Economic Commission for Europe
Inland Transport Committee
World Forum for Harmonization of Vehicle Regulations
Working Party on Passive Safety
Forty-seventh session

Geneva, 17–21 May 2010

**Report of the Working Party on Passive Safety on its
forty-seventh session**
Contents

Figure 1
Jointed test finger

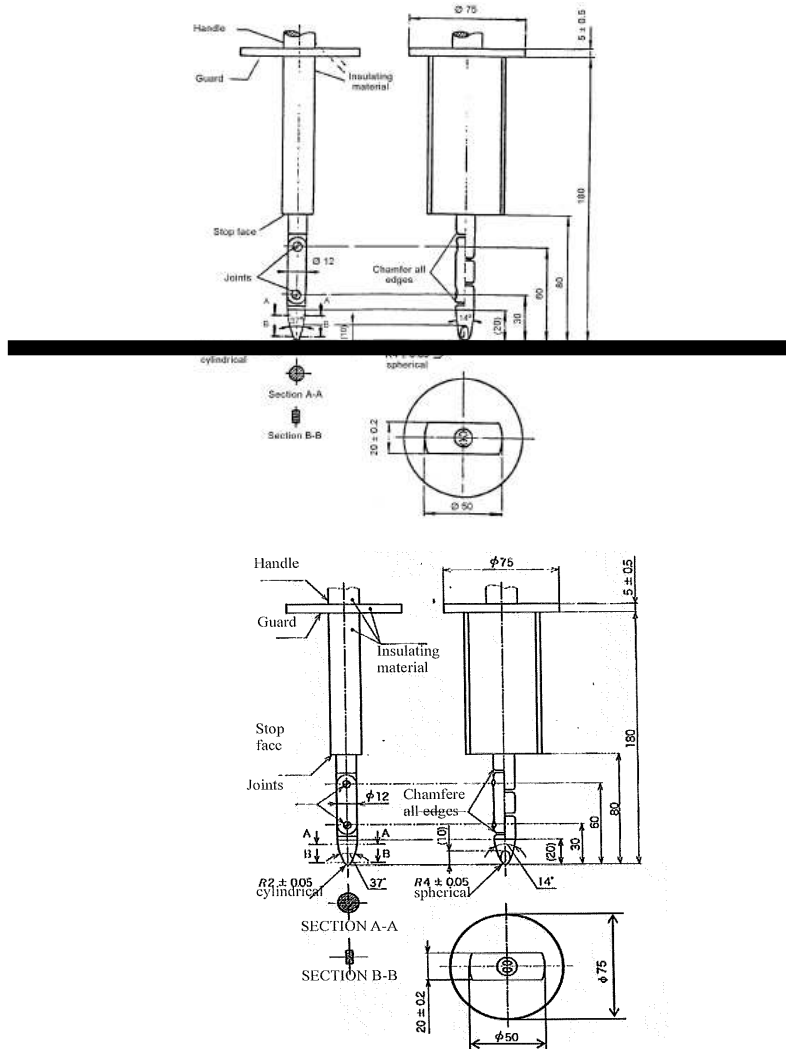
Jointed test finger (IPXXB), shall be deleted
